ADDENDUM #1

Date:	02.25.2014	Addendum No:	1
Project:	York General Health Care Services Hospital Addition And Remodel	Project No:	24902
To:	Jake Kulhanek	Firm:	Sampson

FLOOR PLAN -
AREA "A"

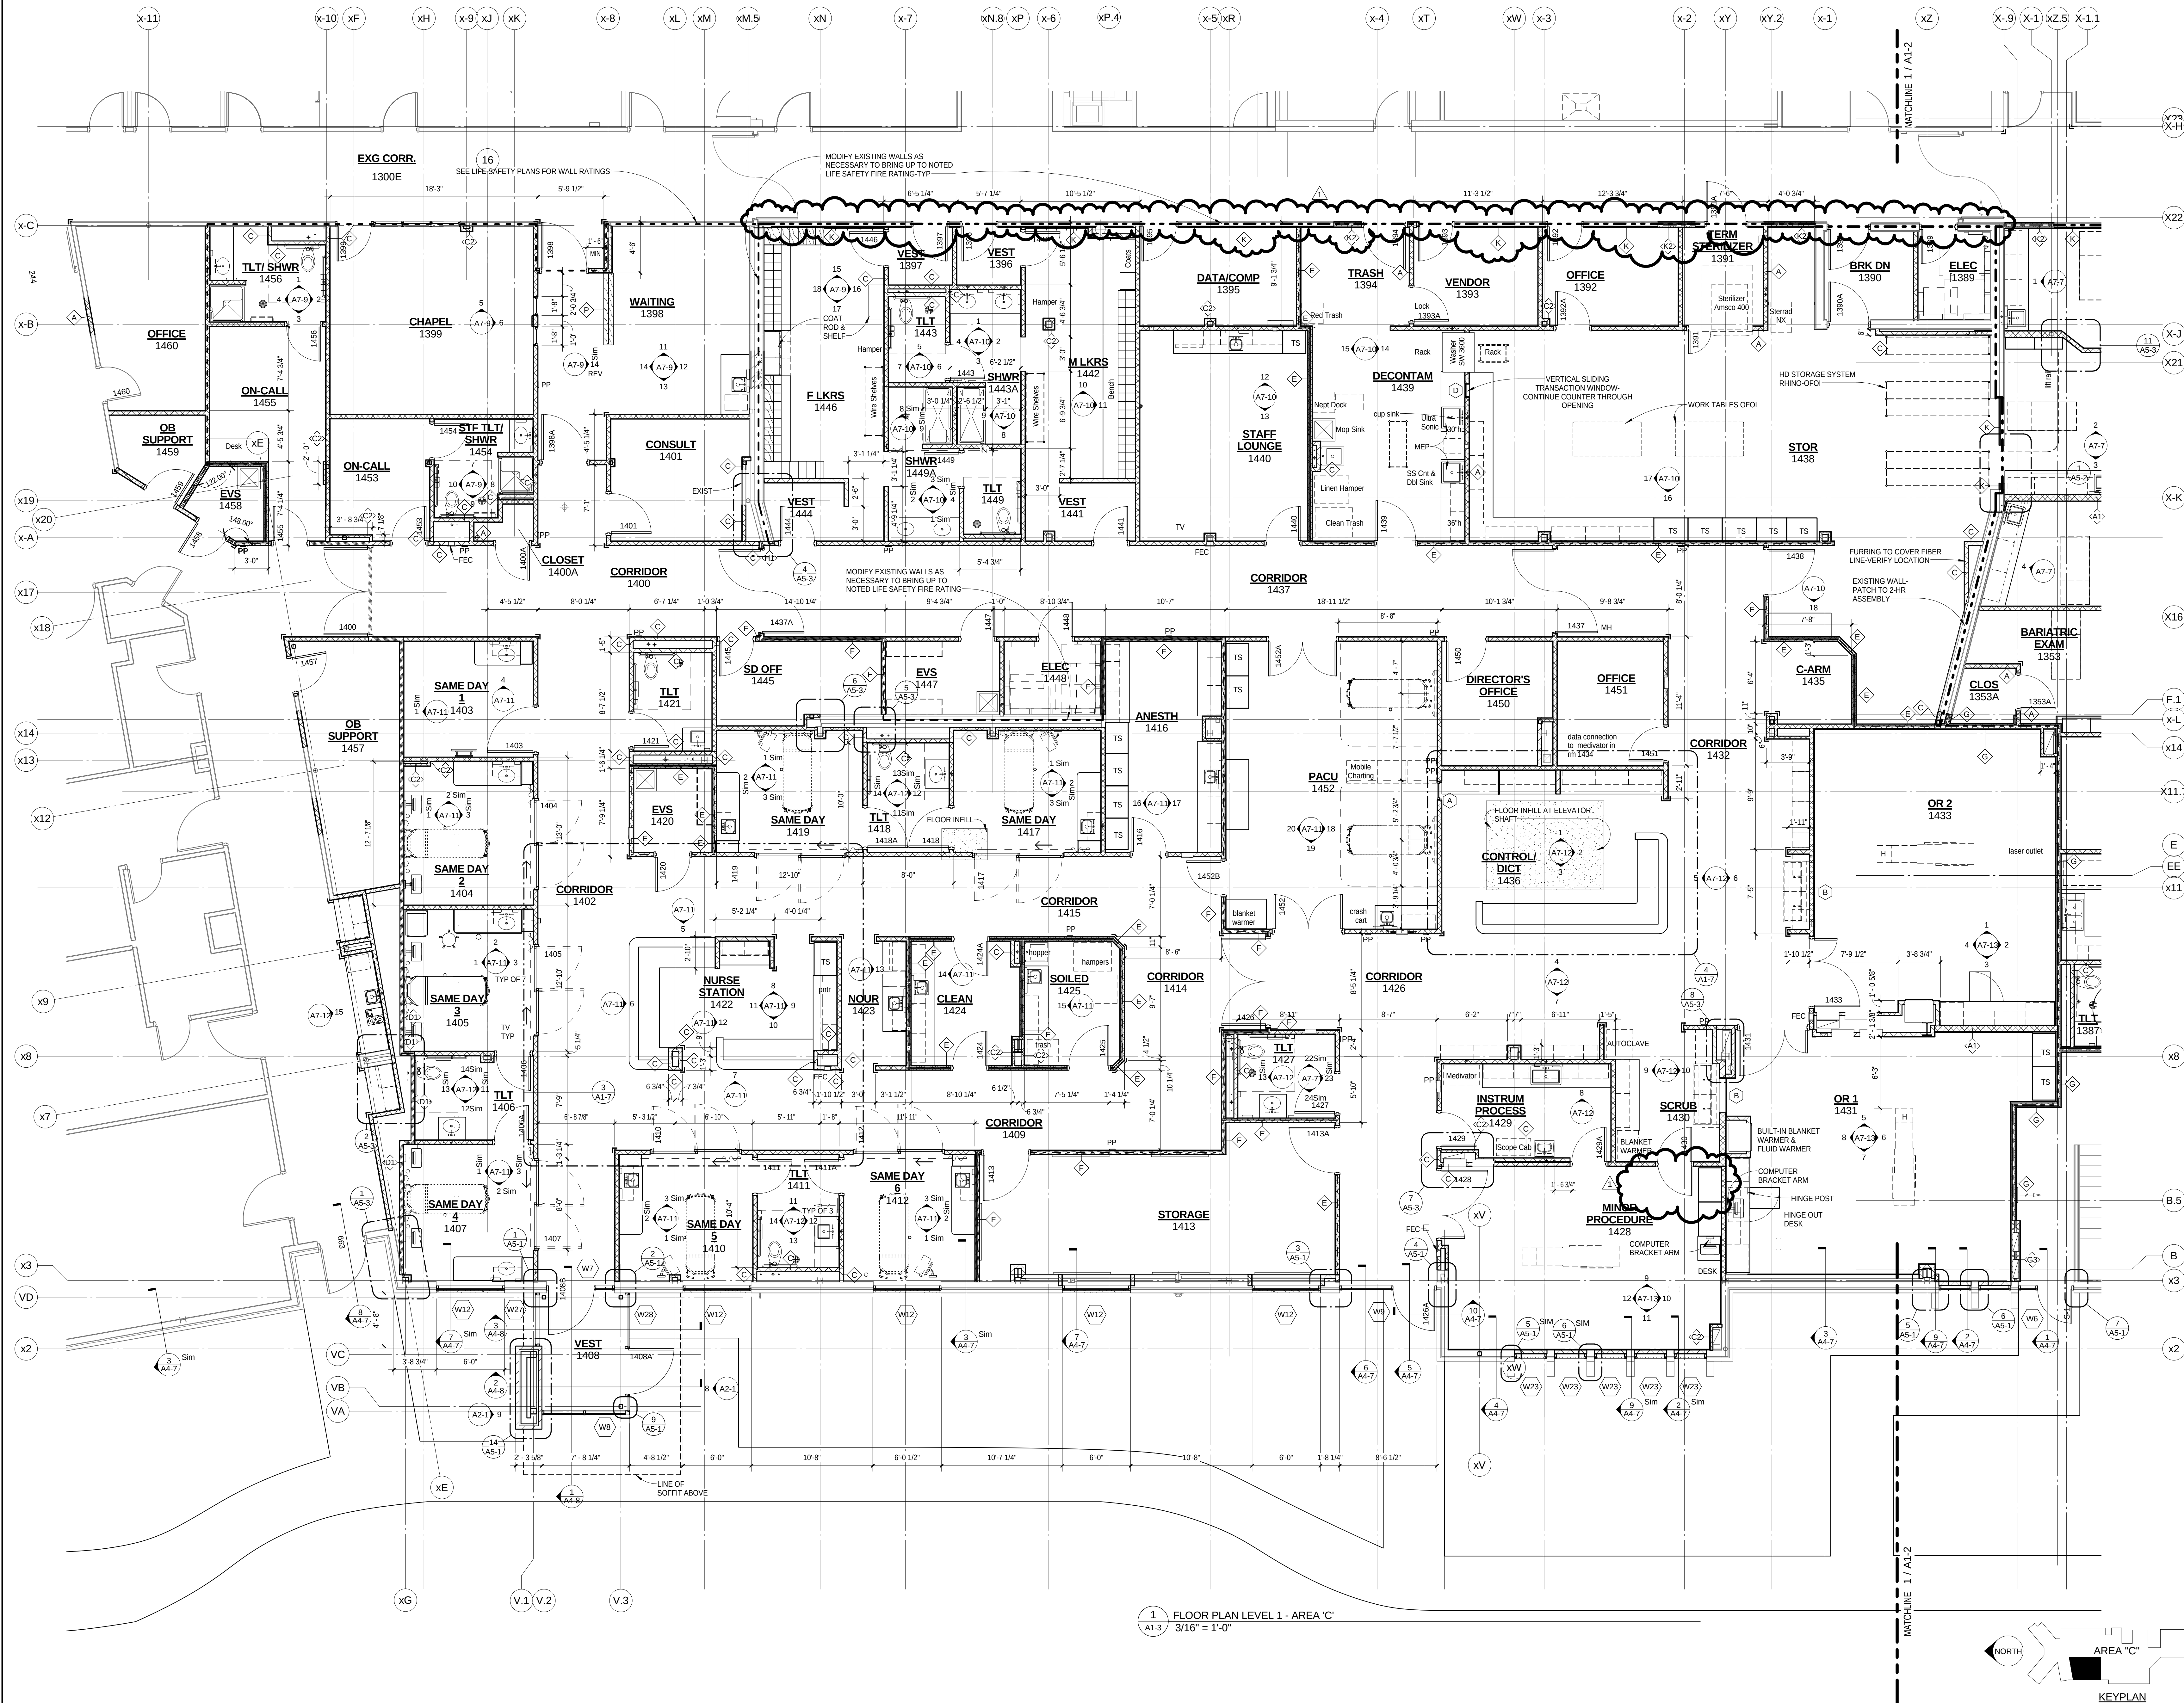
- c. ADULT GYM 1341. Add water coolers and recess on east wall. Add dimensions to south 2-floor trenches. Add casework in southwest corner.
- 9. Sheet A1-2, FLOOR PLAN – AREA “B”. (Reissue in its entirety):

FLOOR PLAN -
AREA "C"

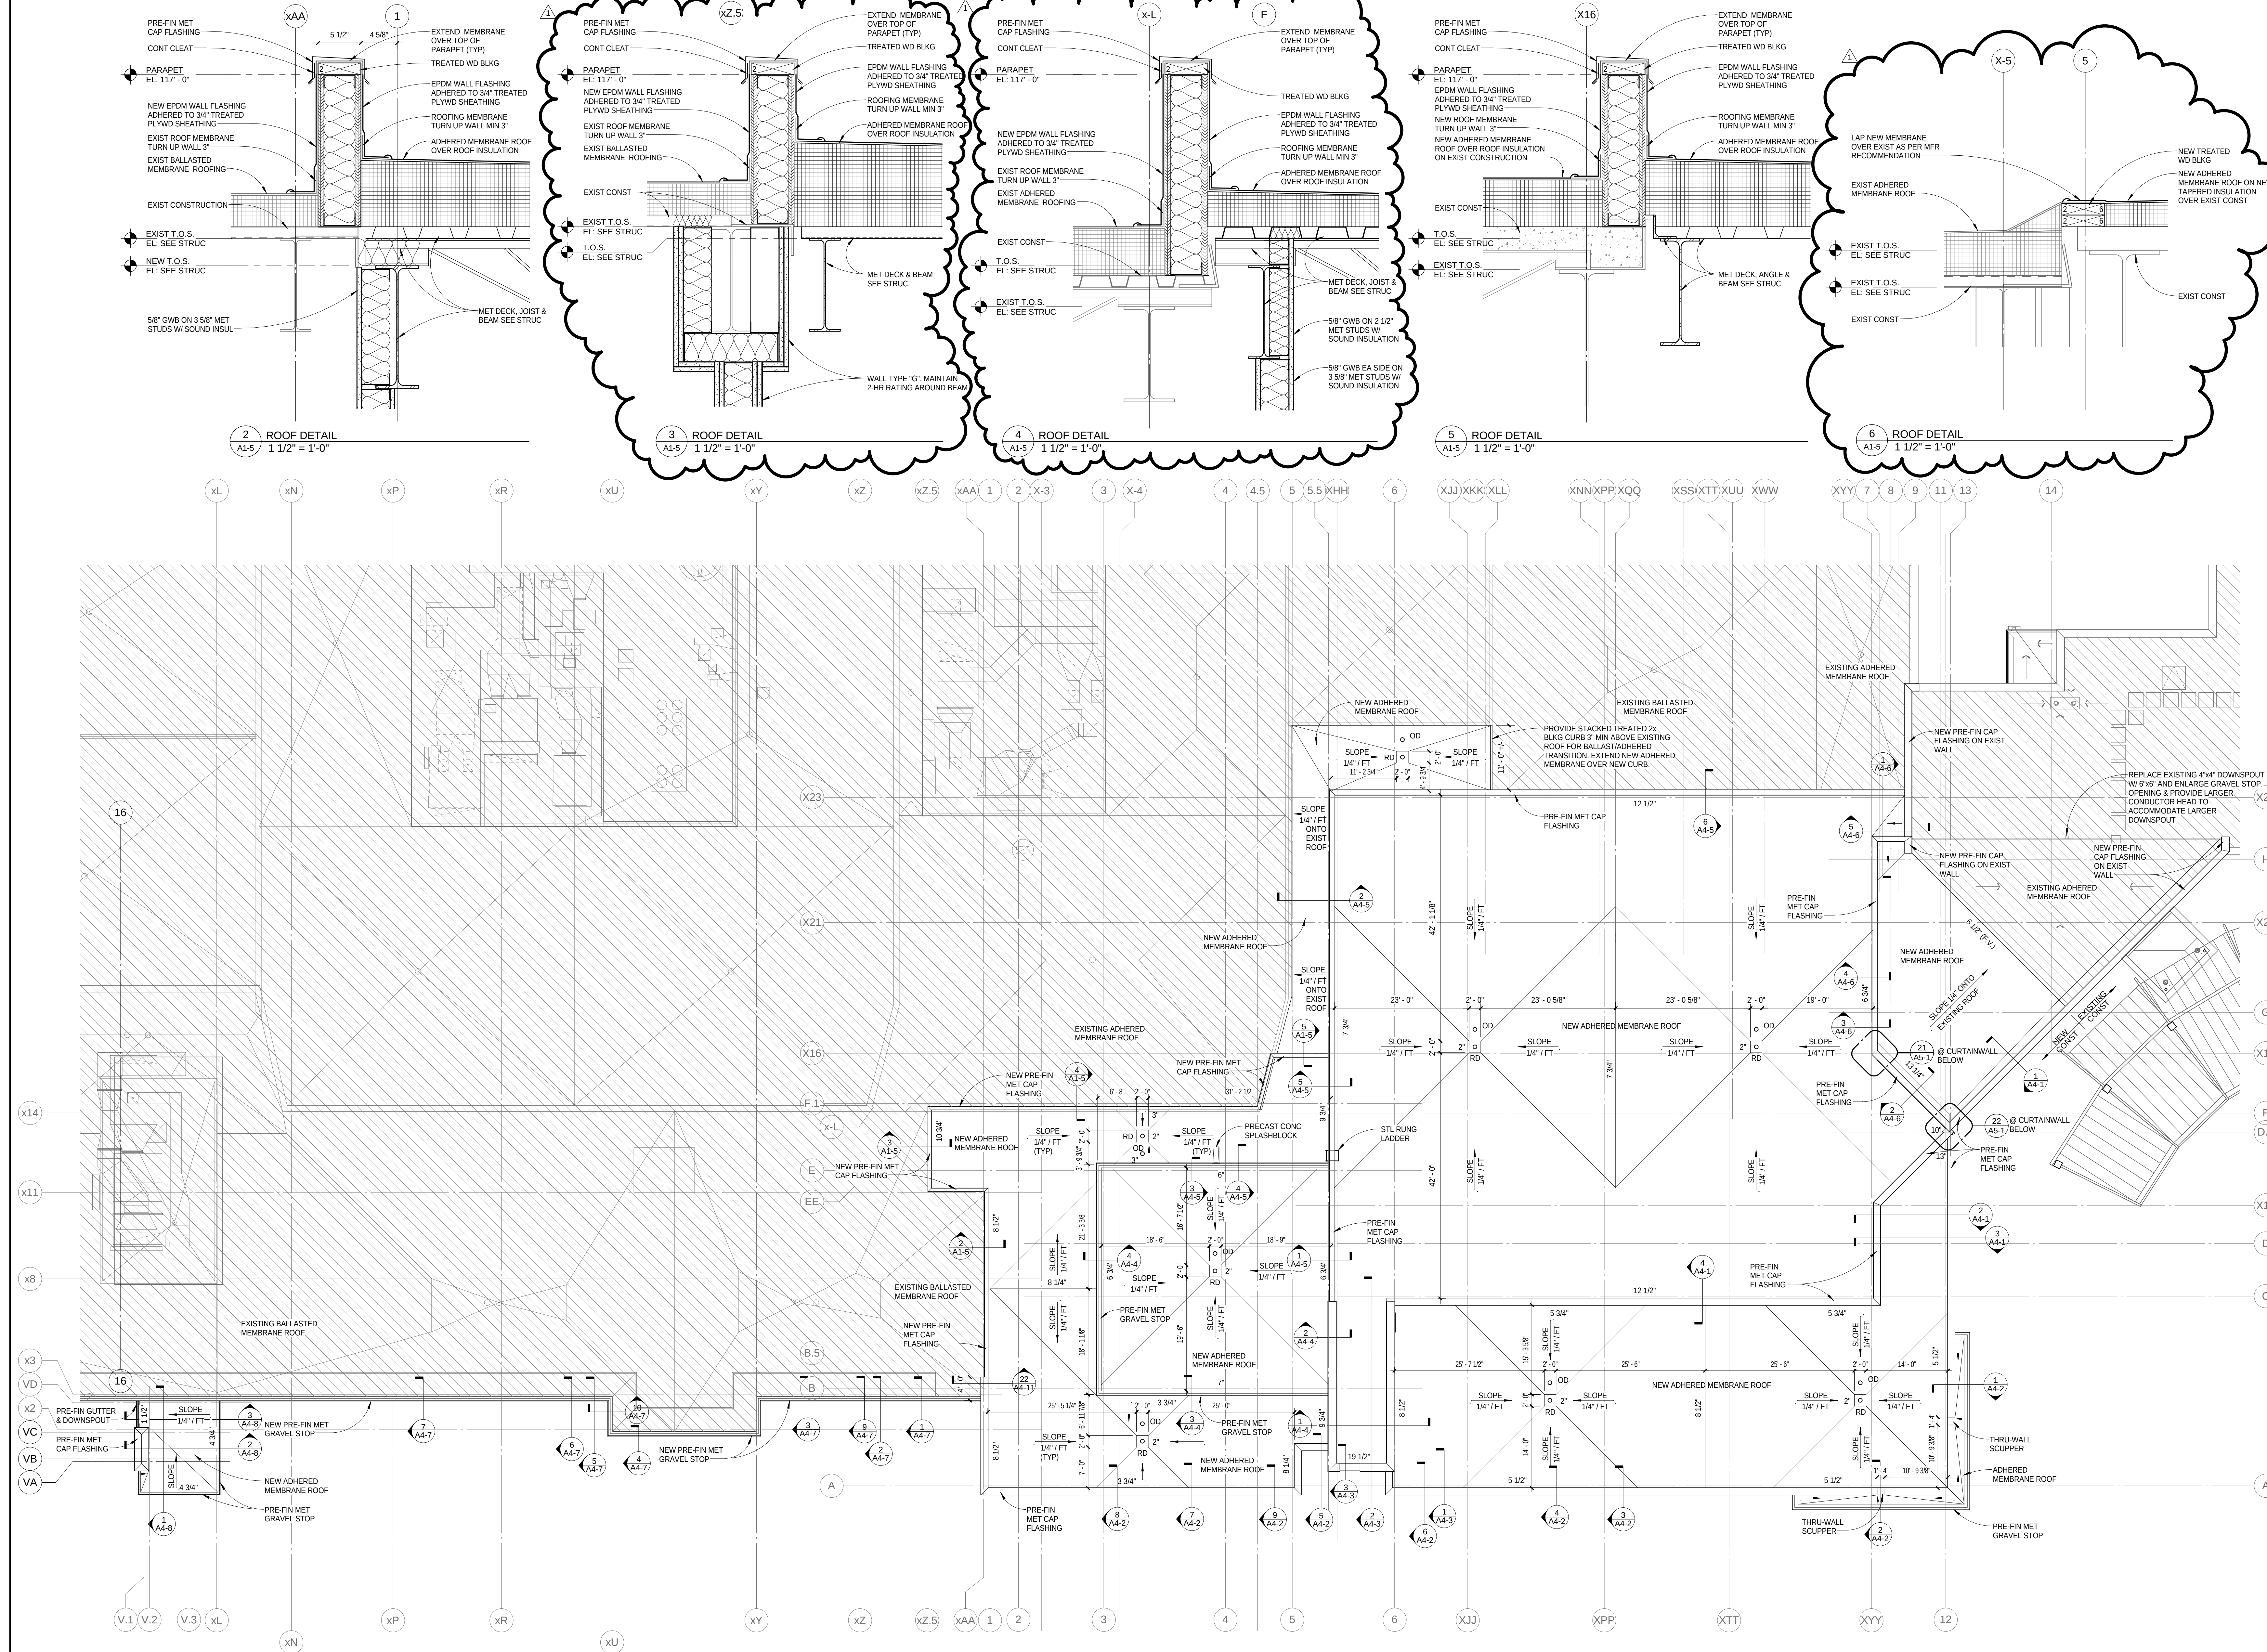
- a. Modified fire rating.
- 10. Sheet A1-3, FLOOR PLAN – AREA “C”. (Reissue in its entirety):
 - a. MINOR PROCEDURE 1428. Move casework, north of door 1430, to east/west wall south of door.

- b. Modified fire rating at main corridor.
- 11. Sheet A1-4, FLOOR PLAN – LEVEL 2. (Reissue in its entirety):
 - a. COPIER/FAX 2010. Delete east end wall cabinet. Add “W3” wall cabinet to north wall.

1 WALL SECTION
1/2" = 1'-0"

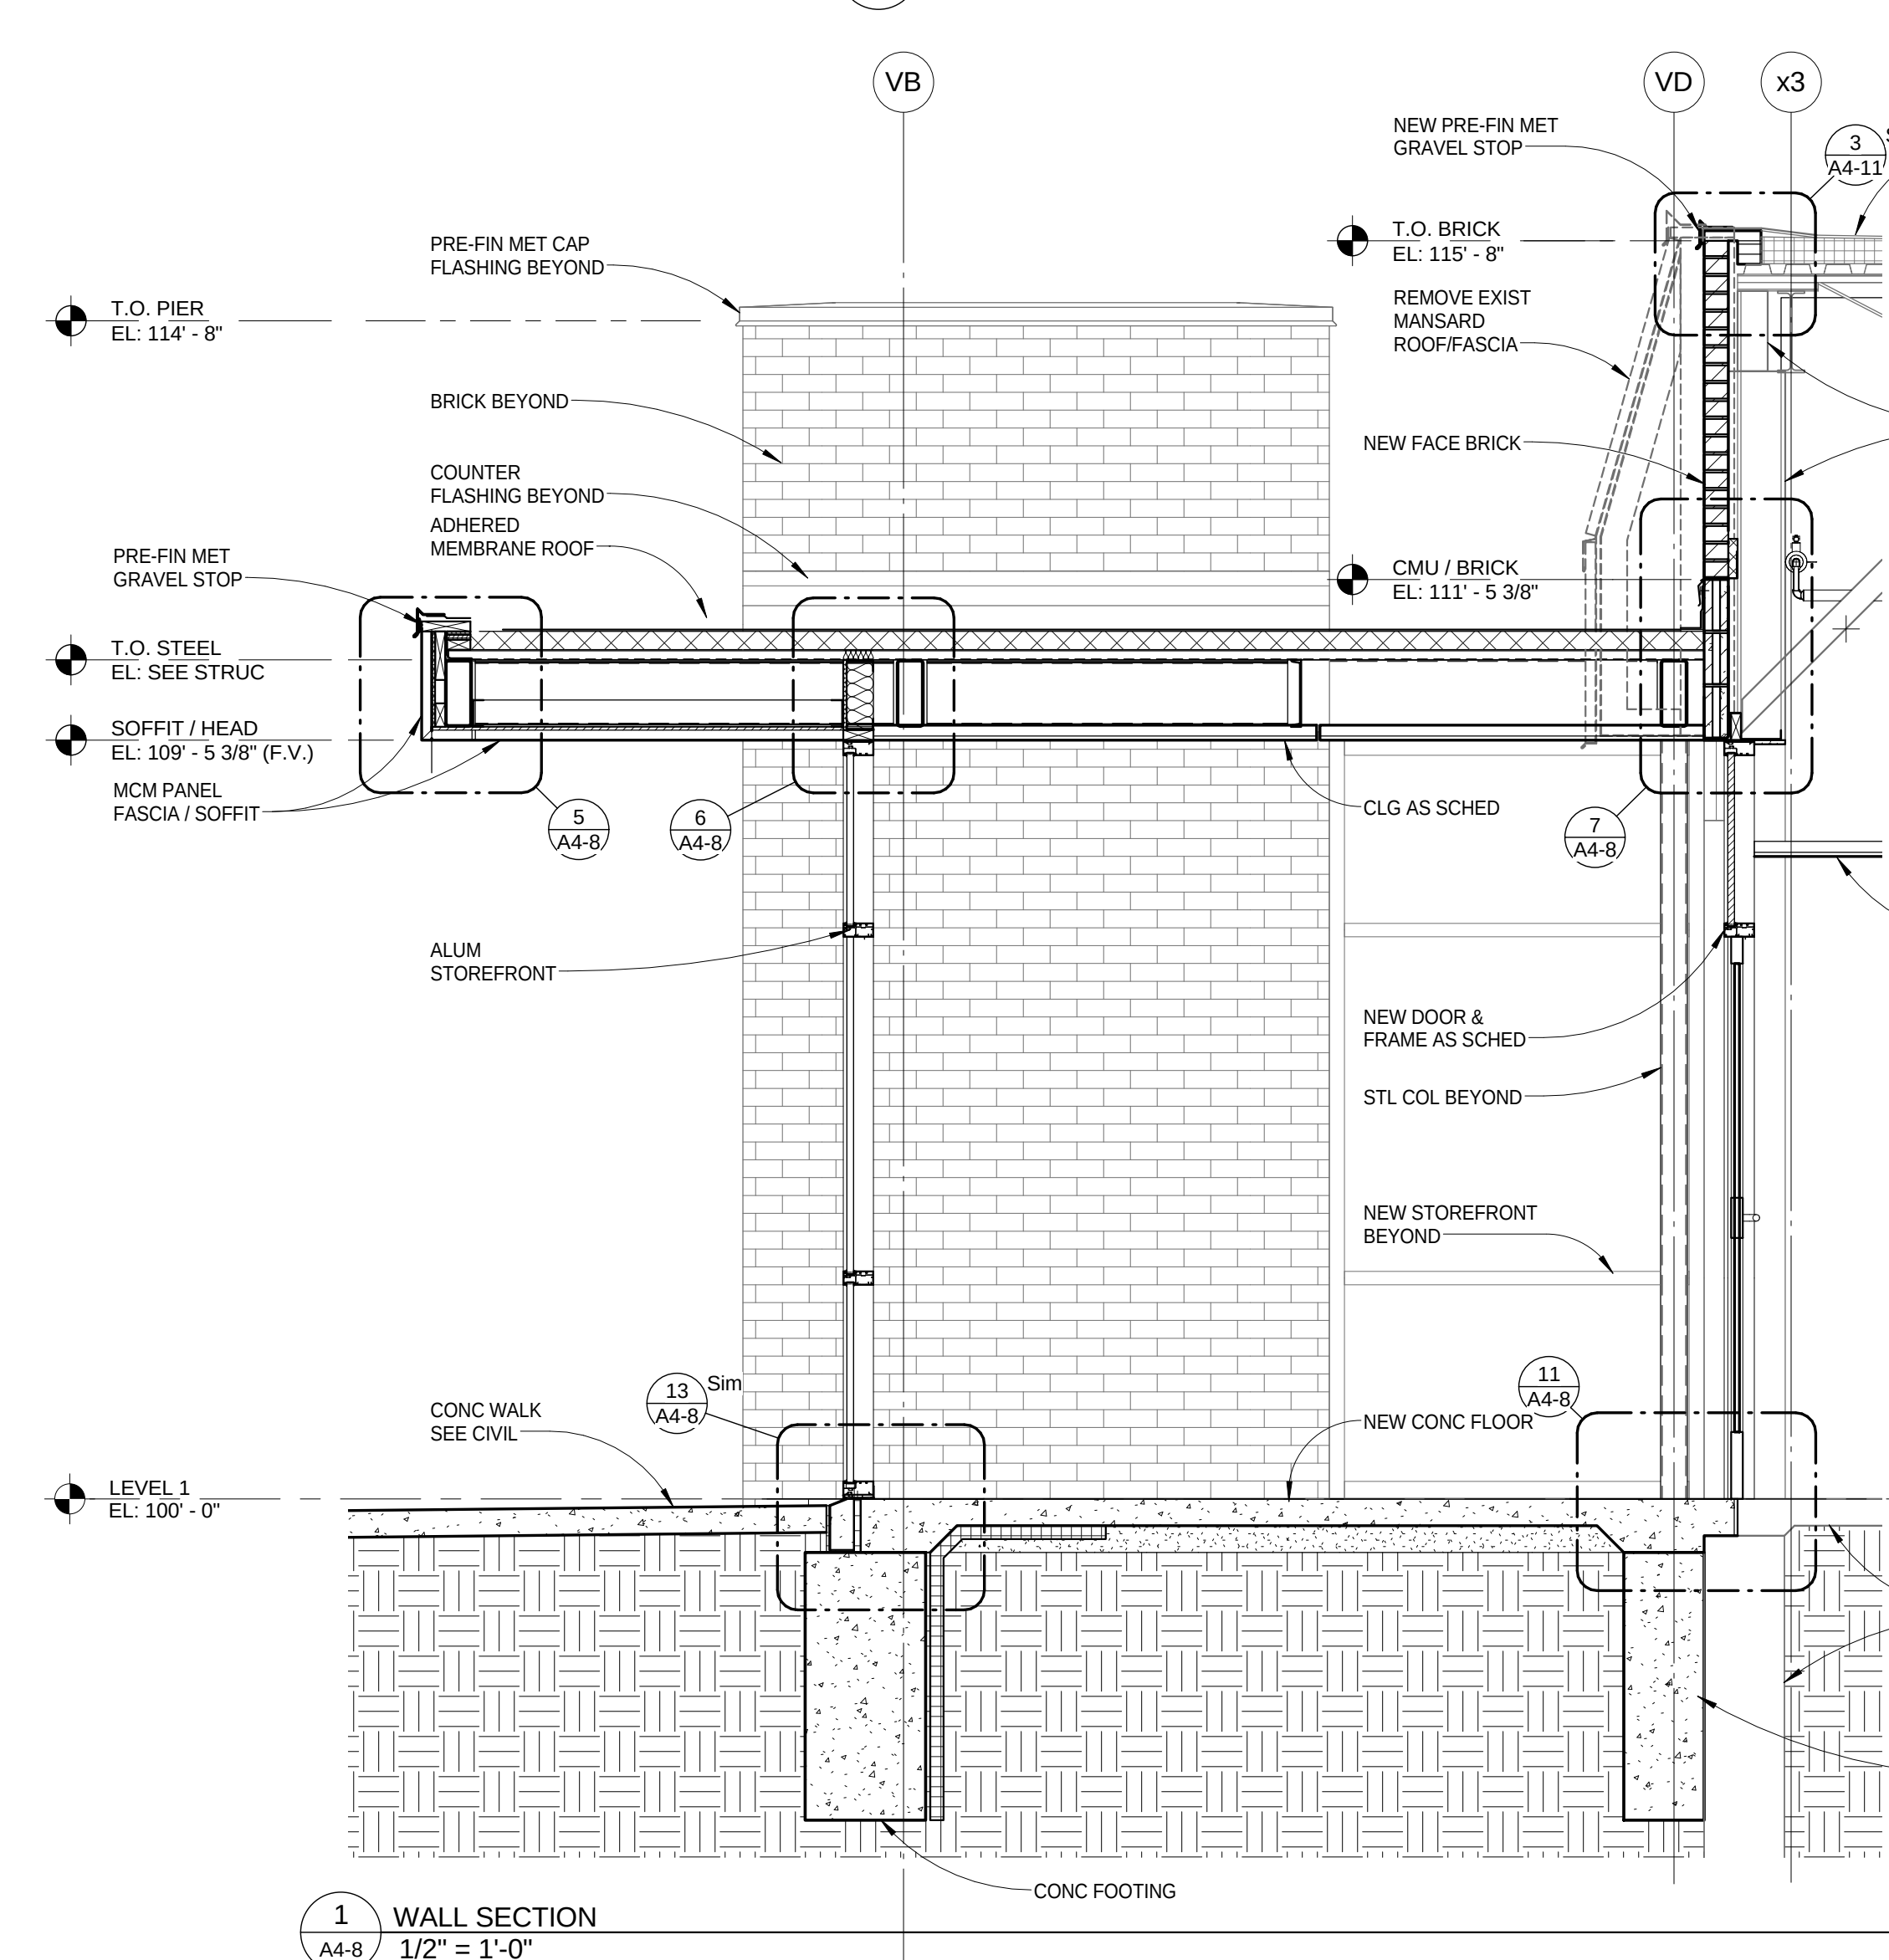
- 18. Sheet A4-1 WALL SECTIONS. (Reissue in its entirety):
 - a. Section 1/A4-1. Add anchor /brace and note “ANCHOR / BRACING CONNECTIONS AS REQUIRED BY CURTAINWALL MFR”.
